Access Compliance Report

Public Rights-of-Way

(Curb Ramps)

Intersection ID: N/A	Main Street: PROVIDENCE_RD	Cross Street: N/A	Location: SW
ADA ID: 6AEC021B05E1	Ramp Type: MedianPerp	Initial Pass/Fail: Fail	Overall Compliance: No
		Severity Score: 13.75

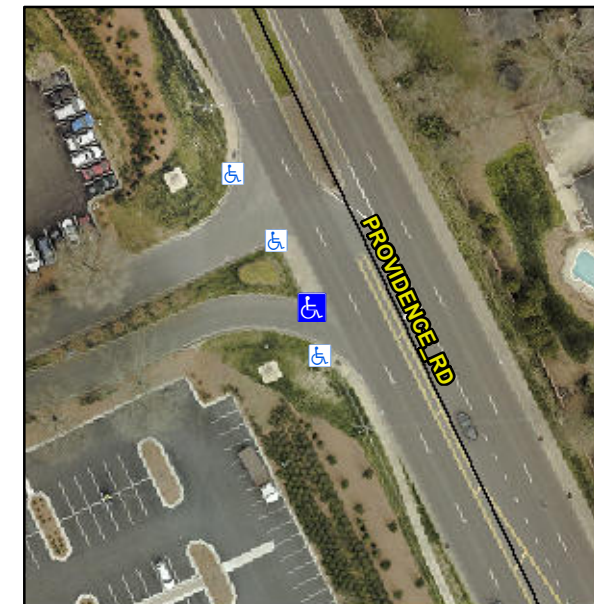
Not Found, R304.2.2, R304.5.3

Compliance	Description	Data	Compliance	Description	Data
N/A	Ramp Length (in)	48.0	No	Ramp Slope (%)	8.7
Yes	Ramp Width (in)	48.0	No	Ramp XSlope (%)	3.7
N/A	Flare Type LT	N/A	N/A	Flare Type RT	N/A
N/A	Flare Slope LT (%)	N/A	N/A	Flare Slope RT (%)	N/A
N/A	Flare Traversable LT?	N/A	N/A	Flare Traversable RT?	N/A
N/A	Landing Length (in)	N/A	N/A	DWS Provided?	N/A
N/A	Landing Width (in)	N/A	N/A	DWS Contrast?	N/A
N/A	Landing Slope (%)	N/A	N/A	DWS Length (in)	N/A
N/A	Landing X Slope (%)	N/A	N/A	DWS Full Width?	N/A
N/A	Landing Curb? (Y/N)	N/A	N/A	DWS Offset (in)	N/A
N/A	Shared Landing?	N/A			
N/A	Gutter Ponding?	N/A	N/A	Gutter Slope (%)	N/A
N/A	Gutter Lip Ht (in)	N/A	N/A	Gutter X Slope (%)	N/A
N/A	Painted X Walk1?	No	N/A	Painted X Walk2?	N/A
	X Walk 1 Direction	To SE		X Walk 2 Direction	N/A
N/A	X Walk 1 Width (in)	N/A	N/A	X Walk 2 Width (in)	N/A
	X Walk 1 Slope (%)	5.5		X Walk 2 Slope (%)	N/A
	X Walk 1 X Slope (%)	2.2		X Walk 2 X Slope (%)	N/A

Remove & Replace Entire Ramp.
